# Technical Service Bulletin

**NUMBER:** 19-02-00 Rev. A

**GROUP:** Steering

Ignition Lock Cylinder Service

**FIGURE 1**

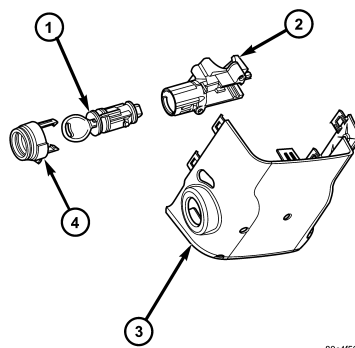
Recent changes to the ignition lock cylinder have resulted in the removal of a chamfer on the lock cylinder retaining pin. This may cause the pin to hang up on the plastic trim ring when the lock cylinder is removed. If this situation is encountered on any of the models listed above, it may be necessary to remove the trim ring prior to removing the lock cylinder. This is done by unseating the retaining tabs on the trim ring and removing it. The lock cylinder can then be removed without any Interference (See Figure 1). Future models will modify the lock housing to eliminate this condition.
